W-6 UPPER SEGMENT: HWY 90 TO SW MILITARY DRIVE SEWER MAIN PROJECT
Solicitation Number: CO-00317
Job No.: 19-4519

ADDENDUM 6
April 9, 2020

RESPONSES TO QUESTIONS

DATE: FEBRUARY 2020	SAWS PROJECT NO. 19-4519	SHEET NO. G35
DESIGN: KFA	KHA PROJECT NO.	
DRAWN: KFA	068665052	
CHECKED: KFA

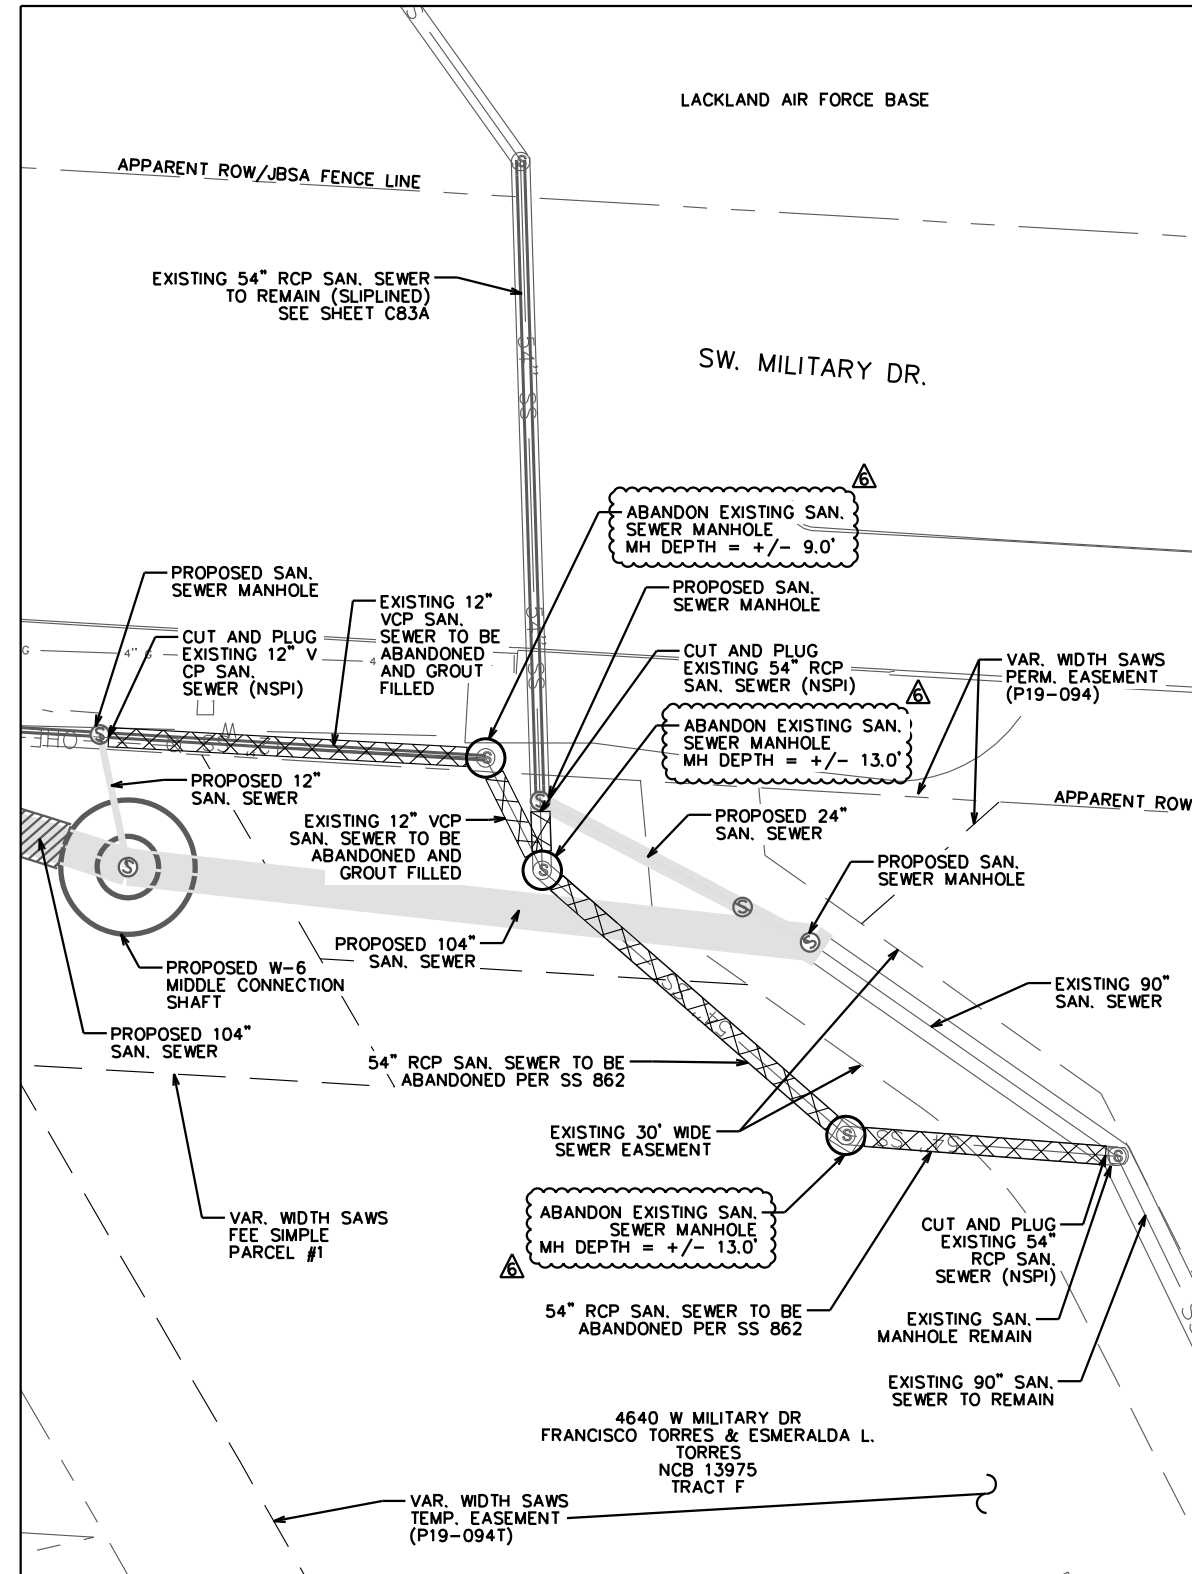
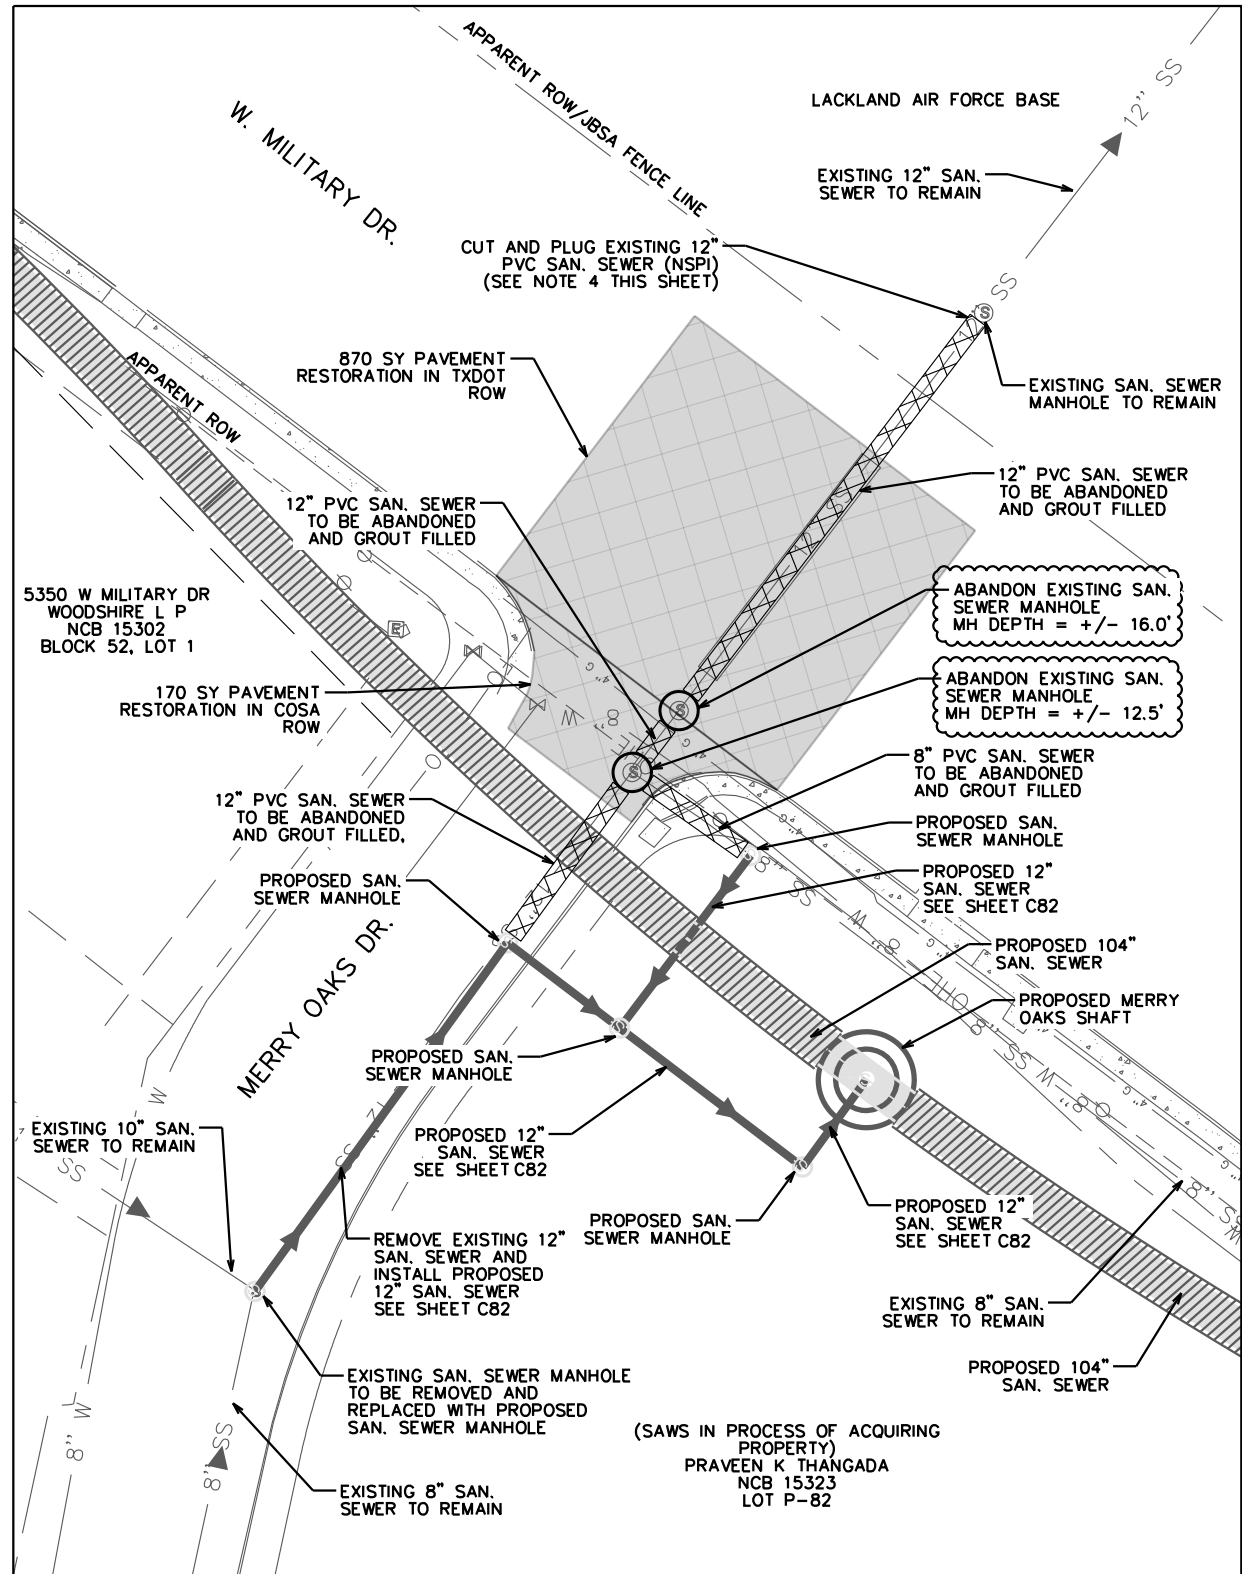
Question: States sanitary sewer manhole shall be filled to the top of the remaining concrete structure with the same material used to abandon the sanitary sewer main. Please provide top, and invert elevations of structures to be abandoned on Sheet G34 though G37

Response: *The depth of manholes to be abandoned has been added to sheets G34-G37, and the revised sheets have been added to this addendum. Please note that the depths provided were taken from SAWS block maps, and are approximate.*

DATE: FEBRUARY 2020	SAWS PROJECT NO. 19-4519	SHEET NO. G37
DESIGN: KFA	KHA PROJECT NO. 068665052	
DRAWN: KFA		
CHECKED: KFA

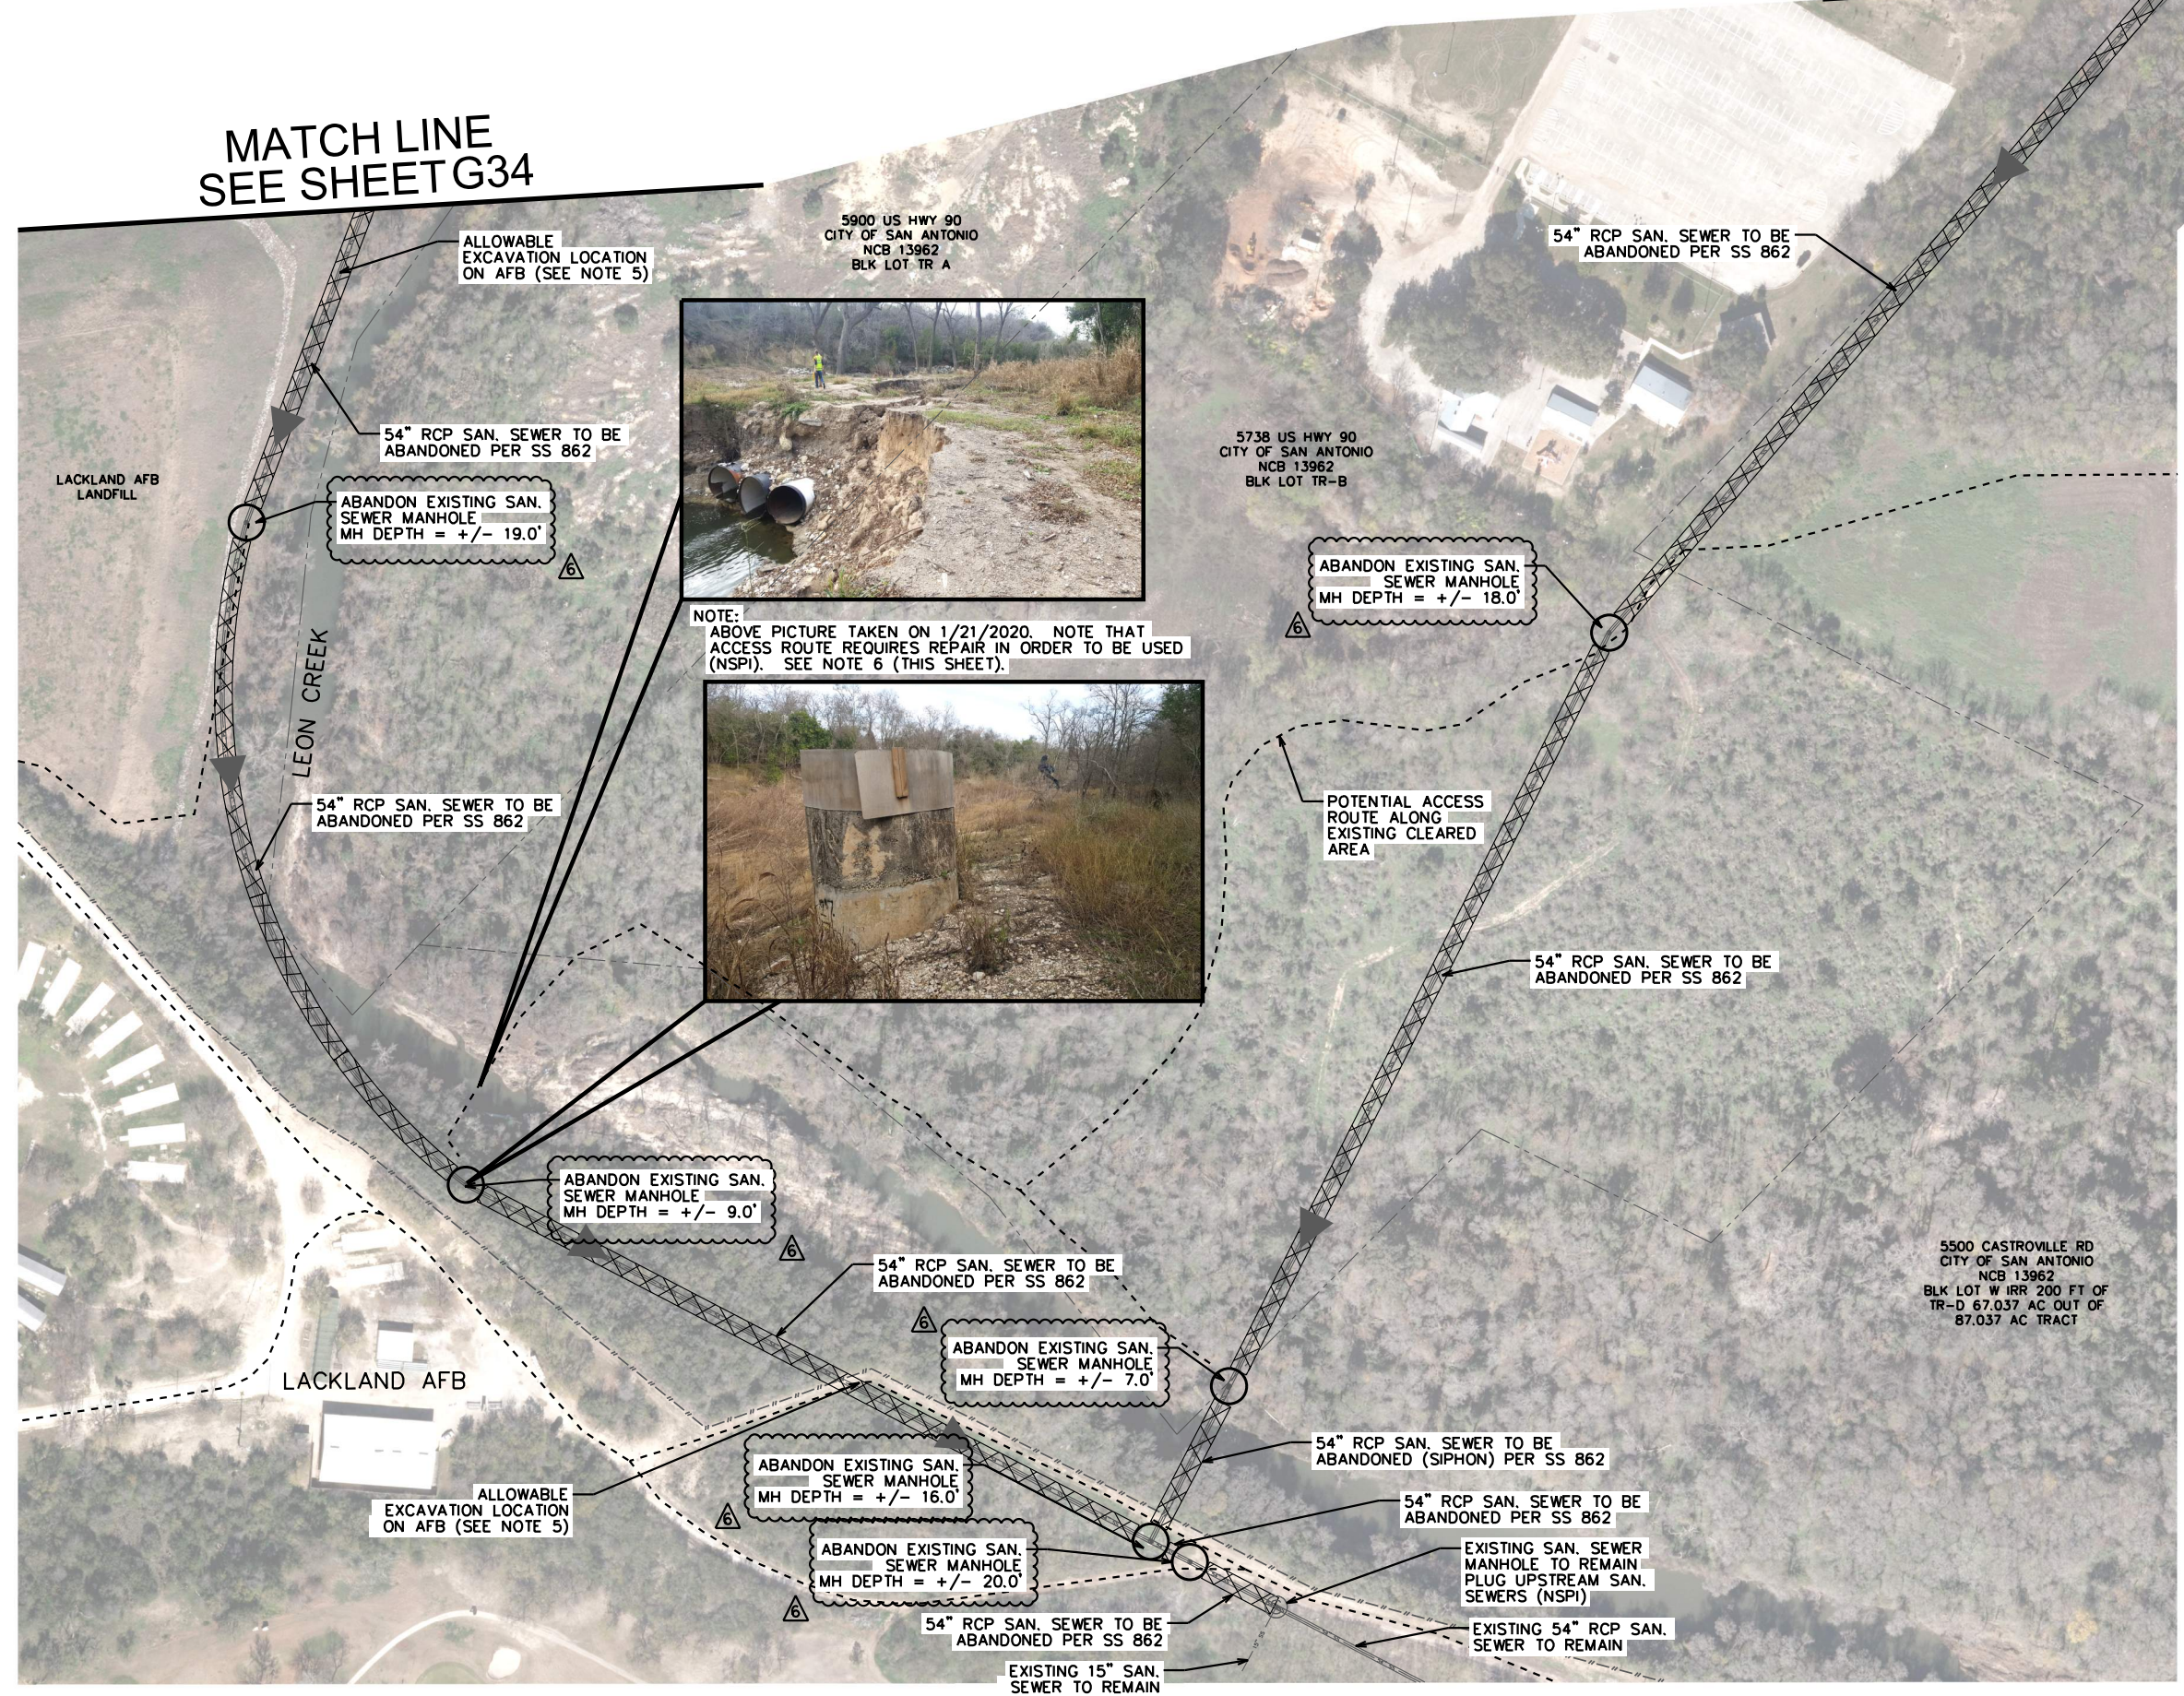
Q47: Sheet G37 Note 5 states, "Excavation locations for installing grout have been coordinated with Lackland Air Force Base"

4. Sheet G36 – Abandonment Plan (Sheet 3 of 4) – Revise and Replace sheet in its entirety.
 - Added approximate depth to manhole abandonment callouts
5. Sheet G37 – Abandonment Plan (Sheet 4 of 4) – Revise and Replace sheet in its entirety.

- Added approximate depth to manhole abandonment callouts
6. Sheet G43 – Suggested Bypass Pumping Layout (Sheet 5 of 5) – Revise and Replace sheet in its entirety.

Response: *JBSA had no issues with contractor access for grouting, and also had no issues with installation of mid-reach grout points between manholes. The exact locations of mid-reach grout points shall be coordinated with JBSA during construction.*

DATE: FEBRUARY 2020	SAWS PROJECT NO. 19-4519	SHEET NO. G43
DESIGN: KFA	KHA PROJECT NO. 068665052	
DRAWN: KFA		
CHECKED: KFA

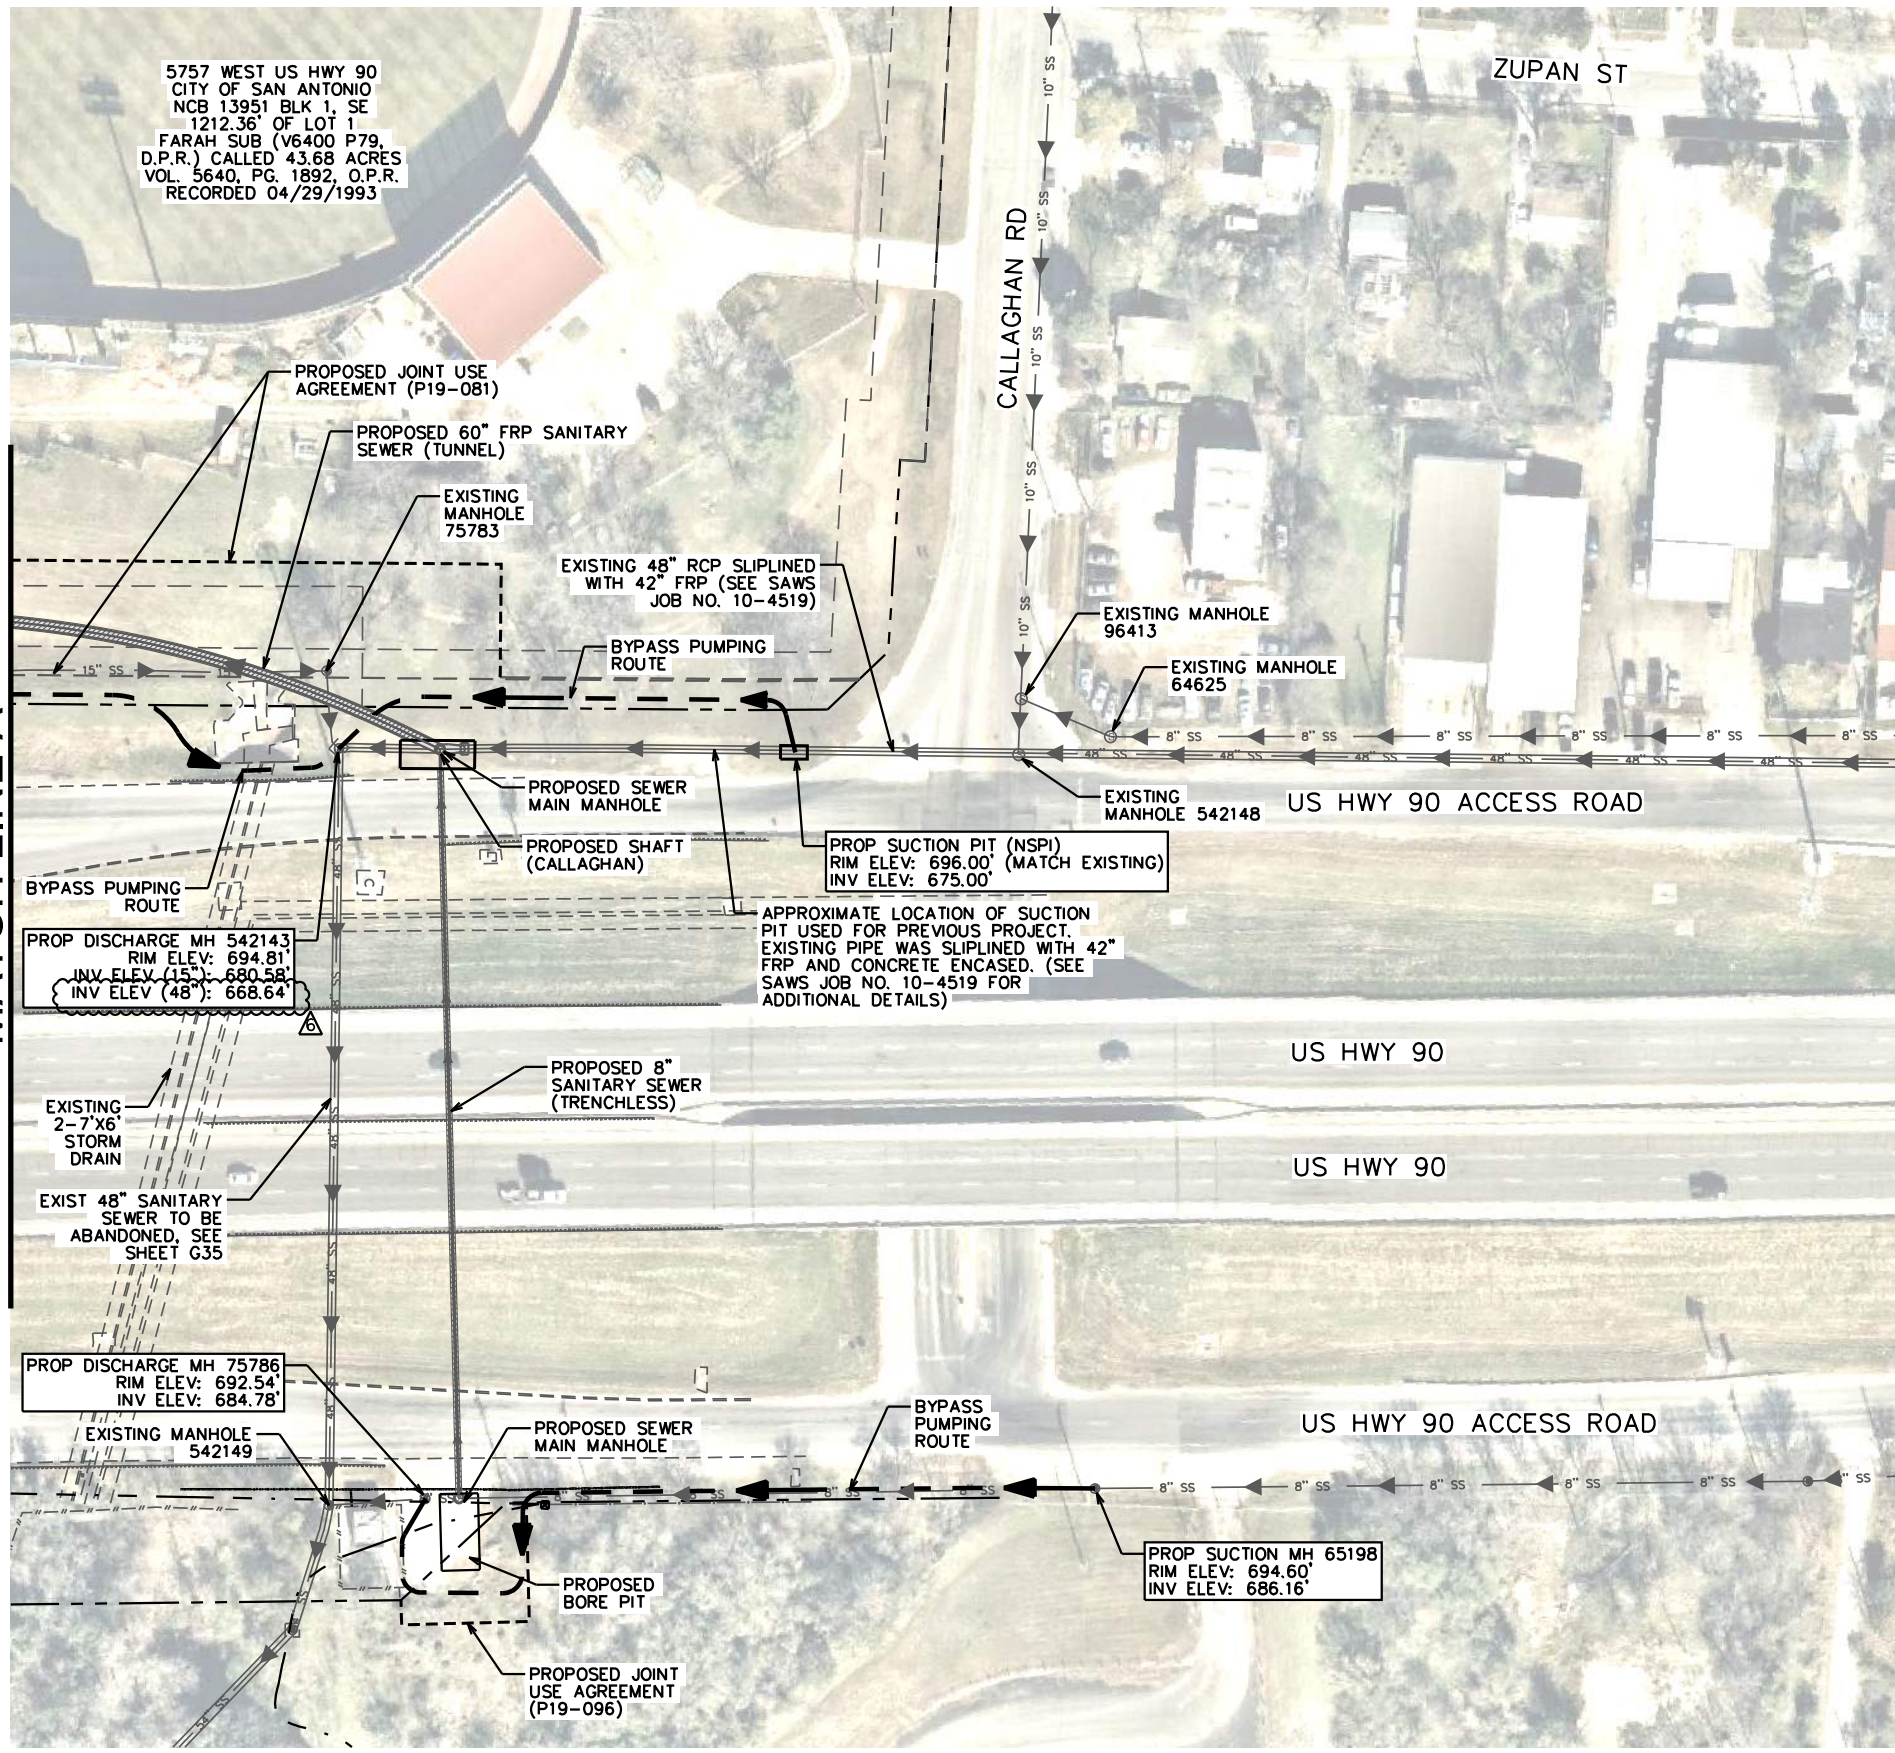
Q45: Sheet G43 and C76. Elevation clarification.

Question: Drawing G43 indicates the 48" discharge from MH 542143 to have an elevation of 674.78'. Drawing C76 upstream of that manhole indicates this project will connect to the system at an elevation of 668.70. Please confirm elevations, almost 6' below the downstream manhole connection.

- Updated invert elevation of MH 542143
7. Sheet S10 - SHAFT #2 (PEARSALL SHAFT) – LOWER LEVEL PLAN AT EL 612.77' - Revise the sheet as below.
 - Add dimension call out for the diameter of the foundation slab that reads “25'-0” Dia (min)”

Response: *The invert elevation on sheet C76 is correct. The invert elevation on sheet G43 has been updated and is included in this addendum.*
